**Grandview Kids Centre**

**T19-02**

**ADDENDUM NO. 1**

**ADDENDUM NO. 01**

**MECHANICAL DRAWING  
LIST, LEGEND, SYMBOLS,  
KEY PLAN, DETAILS AND  
EQUIPMENT SCHEDULES**

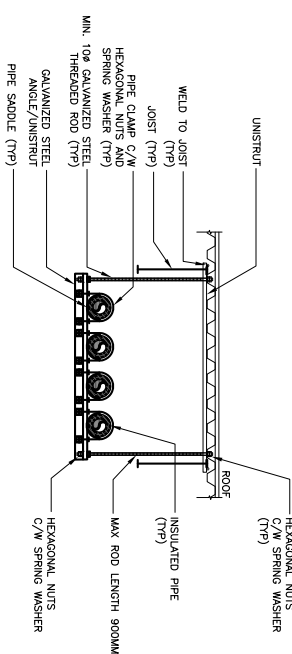
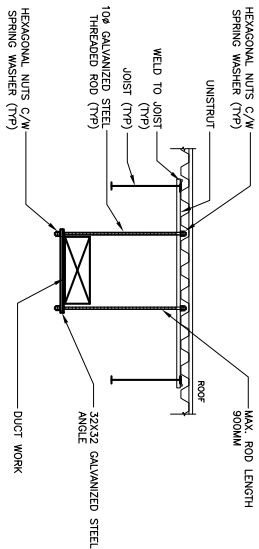
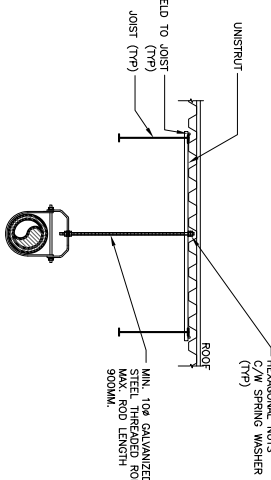
1. **BAS Monitoring & Control of proposed Split AC Units**  
**FC-5, FC-6, CU-1 and CU-2:**

Refer to revised mechanical drawing M-1. The existing school has a JCI Building Automation System (BAS).

Integration of the 2 (two) new split type AC units specified for this project is required to provide the functionality as described below:

1. Remotely enable/disable of the unit from the BAS in addition to local room wired controller.
2. Scheduled start/stop from BAS.
3. Monitoring the operating status of the unit.
4. Failure alarms for each unit.
5. Monitoring the space air temperature.
6. Remote space temperature set point (adjustable) by BAS.
7. Include for a BACnet module for each split AC unit to allow transfer of all data points to BAS in future. This shall be supplied by the split AC system manufacturer and it shall be compatible for BACnet IP and/or BACnet MS/TP protocol.
8. All associated hardware, wiring and conduits to achieve the above design intent.

During construction phase, contractor shall coordinate exact control interface requirements with JCI prior to submission of shop drawings (for equipment and for the BAS work).
